Docket Item # 3  
BAR CASE # 2008-0177

BAR Meeting  
October 22, 2008

**ISSUE:** Alterations  
**APPLICANT:** Robert Bentley Adams & Associates  
**LOCATION:** 917 Oronoco Street  
**ZONE:** RB/Residential

Figure 1: Site plan showing balcony location and rooftop HVAC unit

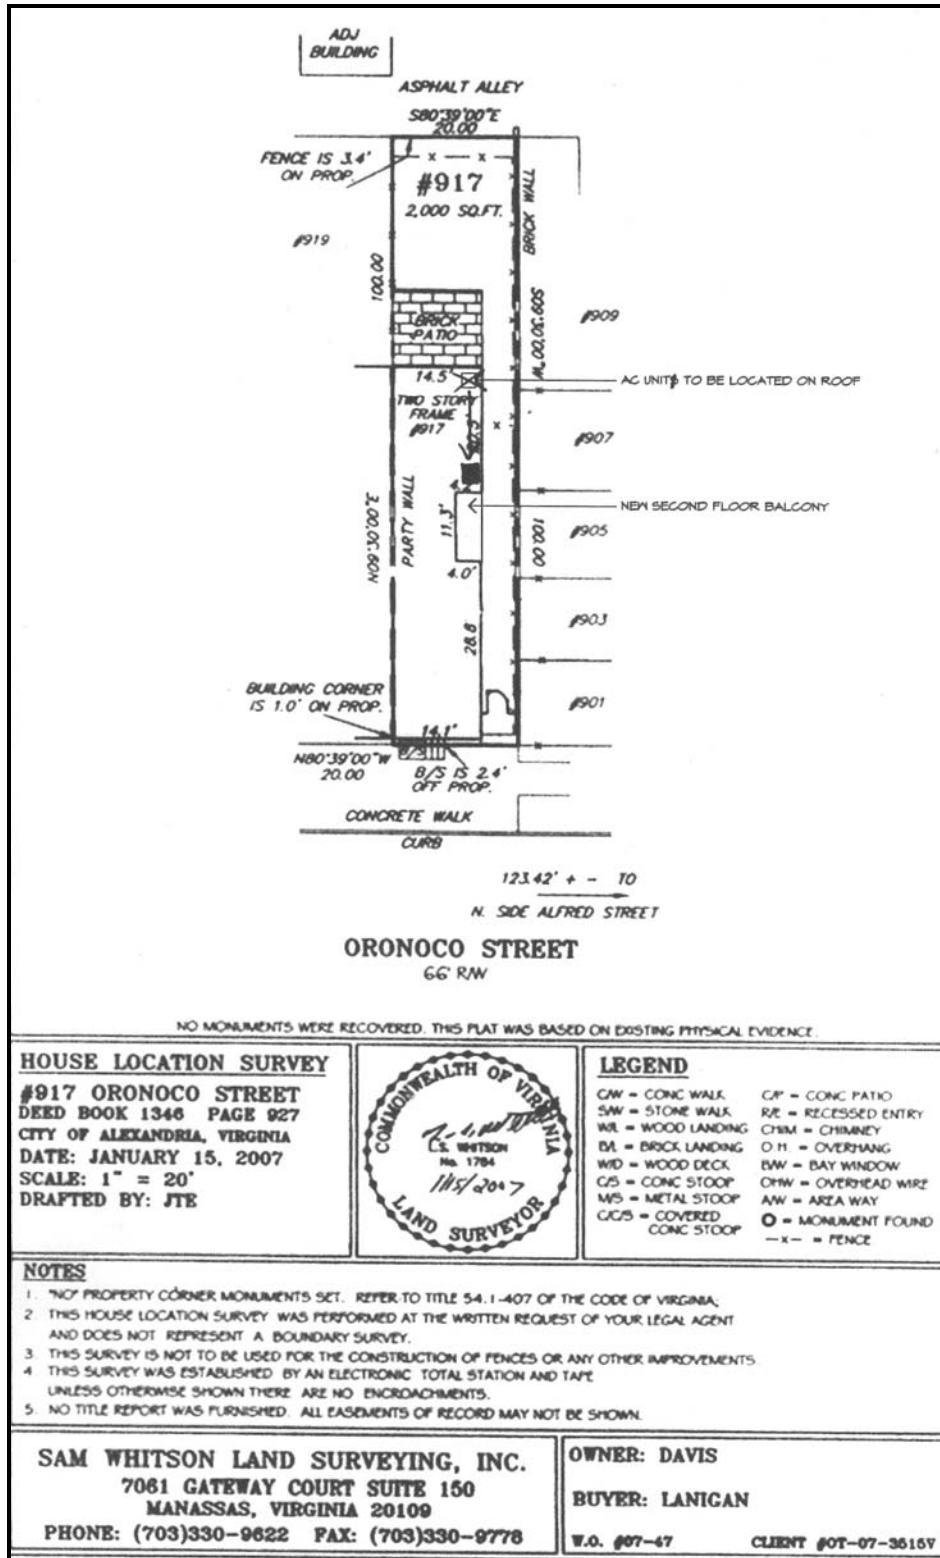
- C-6 A wall location plat prepared by a land surveyor is required to be submitted to this office prior to requesting any framing inspection.
- C-7 Where appliances are located  $\leq 10'$  from a roof edge or open side with a drop  $\wedge \geq 24"$ , guards shall be provided (USBC 2801.1)

- C-8 Structural calculations are required to verify the ability of the existing roof to support the additional weight of the A/C unit.
- C-9 Guardrails and intermediate rails must comply with USBC 1012.1.
